Environmental Protection Agency

Comment 1: Purpose/Legal Authority, last paragraph, p. 3: We note that the Coyote Station Permit to Construct is contained in Appendix A not Appendix D. Please clarify.

MR Young Unit 2 Economizer Outlet Temperatures

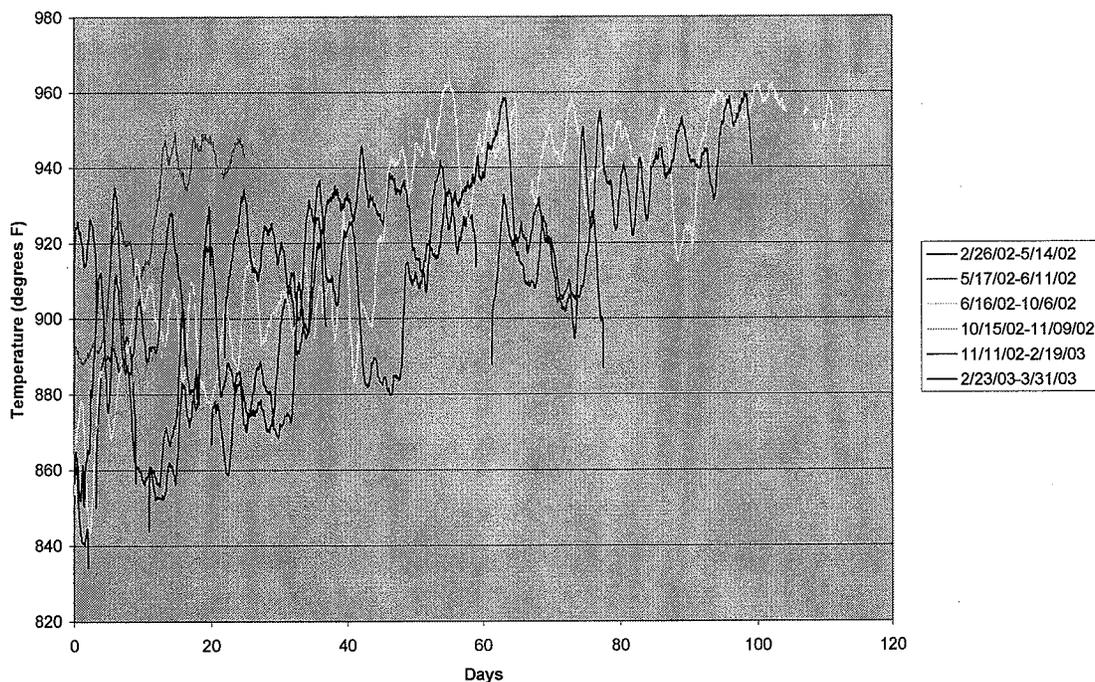
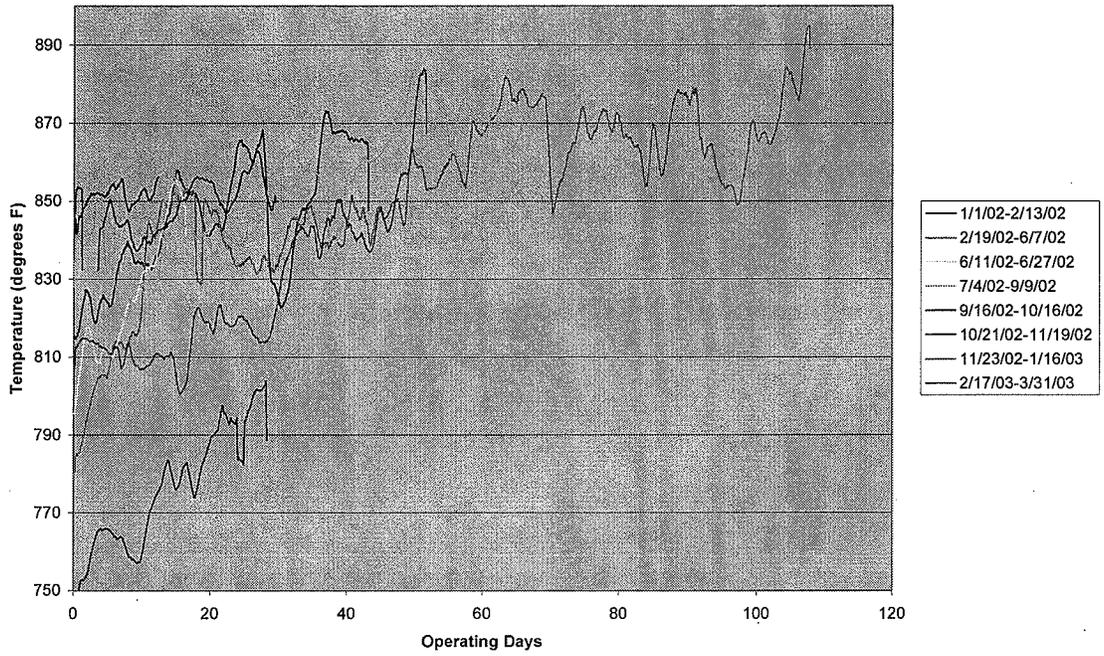
NDDH Request #10: Provide additional clarification and technical justification regarding Minnkota's determination that the units at MRYS are boiler limited and cannot generate additional steam for flue gas reheating purposes.

The steam turbine-generators at MRYS have a given output (gross megawatts) based on steam pressures, temperatures and flow rates related to the boilers. Removing high pressure/high temperature steam to use for flue gas reheating will directly cause a reduction in electrical output. This output reduction cannot be compensated for by increased boiler steam generation without unreasonable consequences. The boilers generate steam based upon their fuel heat input (firing) rates and capacities to absorb the heat created from the fuel combustion. The efficiency of converting fuel heat to steam to megawatts (heat rate or Btu per gross kilowatt) is limited by many factors. Fuel characteristics and boiler capacity are factors that impact heat rate (efficiency) that are not easily changed in the positive direction. The current fuel quality coming from the adjacent mine is not within the original design parameters of the boilers.

Because of the firing type (cyclone) and characteristics of North Dakota lignite burned and resulting flue gas emissions and ash produced at MRYS, the amount of fouling of the heat-absorbing surfaces within the boiler system is severe. These fouling conditions cause high exit flue gas temperatures that eventually reach the maximum limit recommended for maintaining the integrity of the air preheaters. This is indicated by the

Figure 1
Average Cost Effectiveness of NOx Combustion Controls and SCR

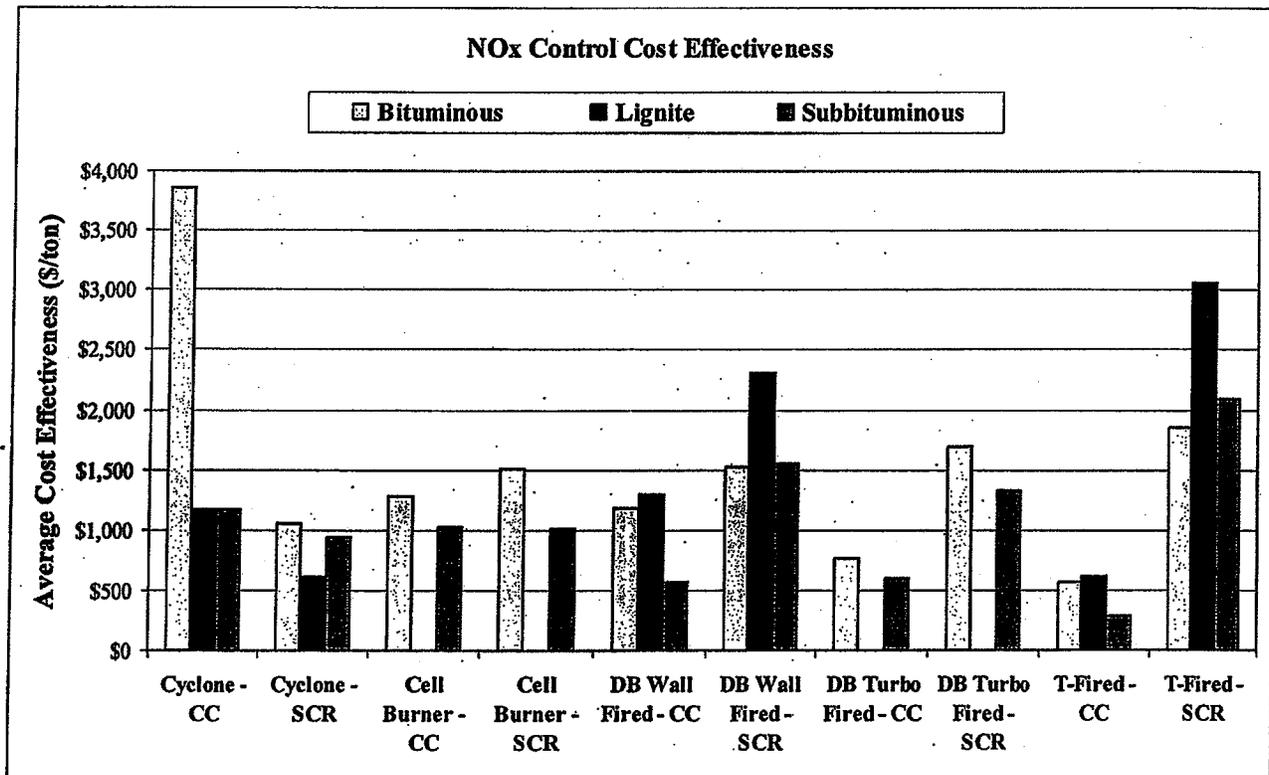
SCR control systems were found to be less cost-effective on all boiler types except Cyclone Boilers. The cost-effectiveness of SCR for all boiler types other than cyclones averaged between \$1,383/ton (Cell Burners) and \$2,012/ton (T-Fired units). The cost-effectiveness of SCR control on Cyclone Boilers was determined to average \$901/ton. The average cost effectiveness of combustion controls and SCR for each boiler type and fuel (i.e., bituminous, lignite, and subbituminous) are shown in Figure 1.

Based on the cost impact results summarized in Figure 1 EPA concluded that combustion controls could cost-effectively reduce NOx emissions on all boiler types other than cyclones, while post-combustion controls, including SCR, were excluded from EPA's presumptive BART determination based on cost impacts.

**Figure 2
Average and Incremental Cost Effectiveness of NOx Retrofit Controls**

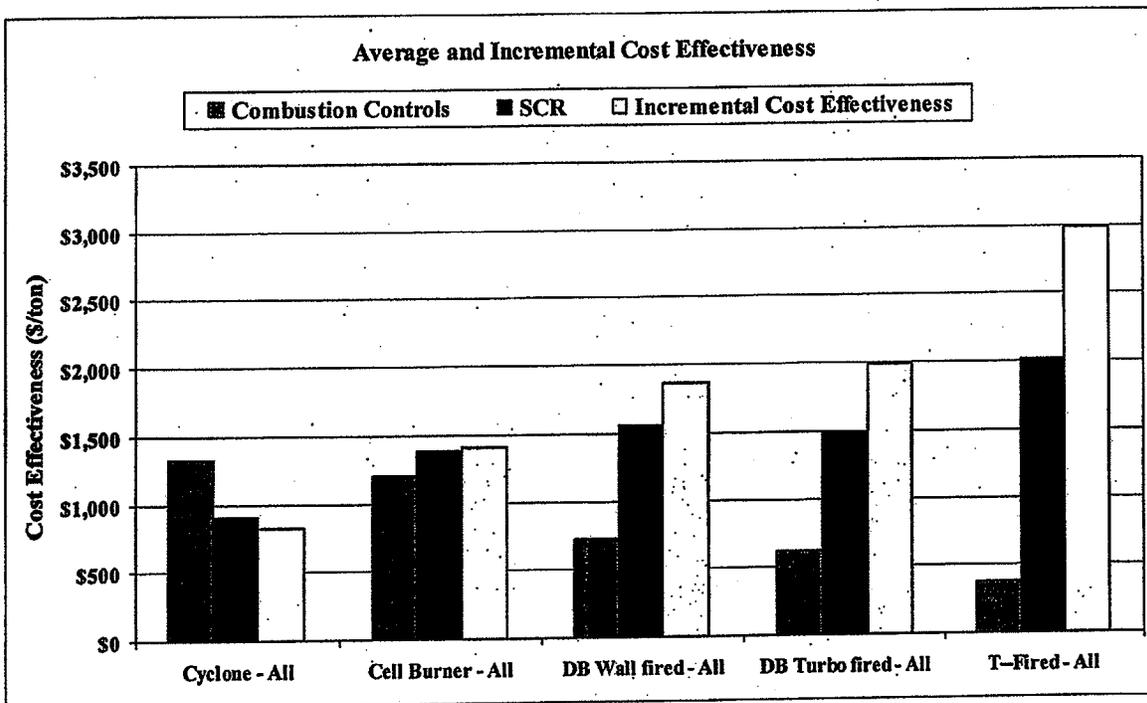
For all boiler types other than cyclones, combustion controls were determined to be a cost-effective NOx retrofit control option while post-combustion SCR was not considered to be cost-effective. Combustion controls had an overall average cost effectiveness (calculated by dividing total annual costs by total annual tons of NOx removed for all boiler categories other than cyclones) of approximately \$535/ton, and ranged from \$281/ton (T-Fired subbituminous units) to \$1,296/ton (DW Wall-Fired lignite units). SCR had an overall average cost effectiveness of \$1,749/ton, ranging from \$1,016/ton (Cell Burner – subbituminous) to \$3,060/ton (T-Fired lignite units). Other than Cyclone Boilers, the Cell Burner category had the highest combustion control cost-effectiveness and the lowest SCR cost-effectiveness at \$1,198/ton and \$1,383/ton, respectively.

Figure 3
Average and Incremental Cost Effectiveness of NOx Retrofit Controls
Showing Cost-Effectiveness Thresholds

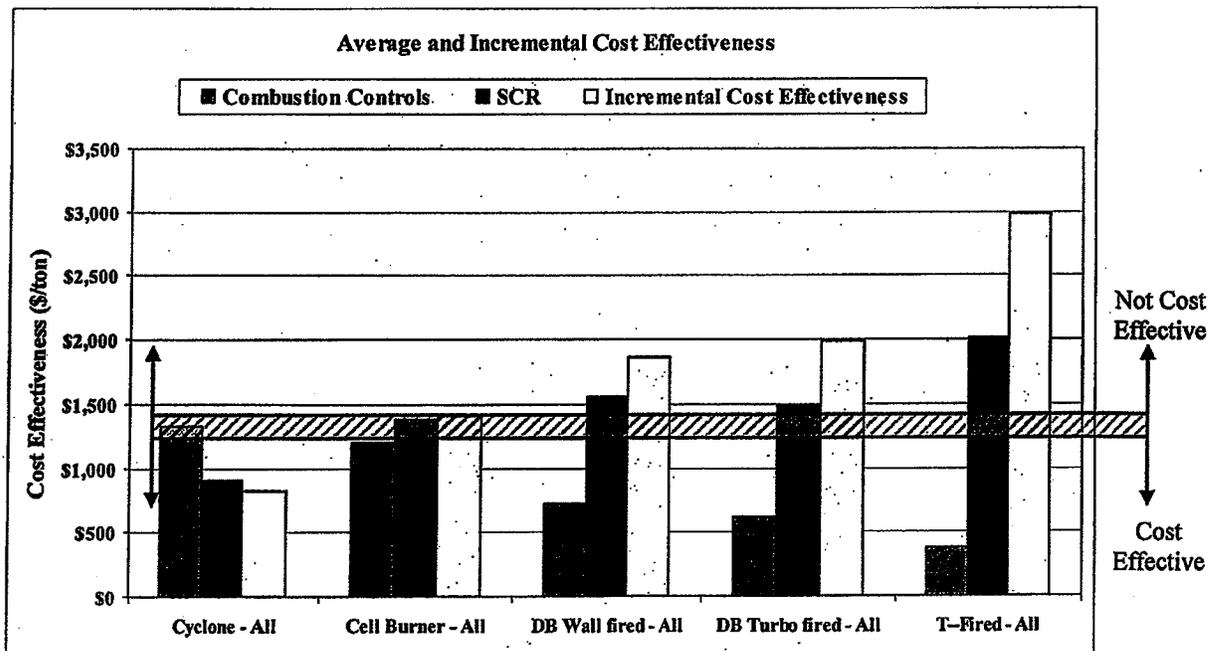
Figure 3 shows the average and incremental cost-effectiveness for combustion controls and SCR on each boiler type, and shows the approximate thresholds used by EPA to establish cost-effectiveness.
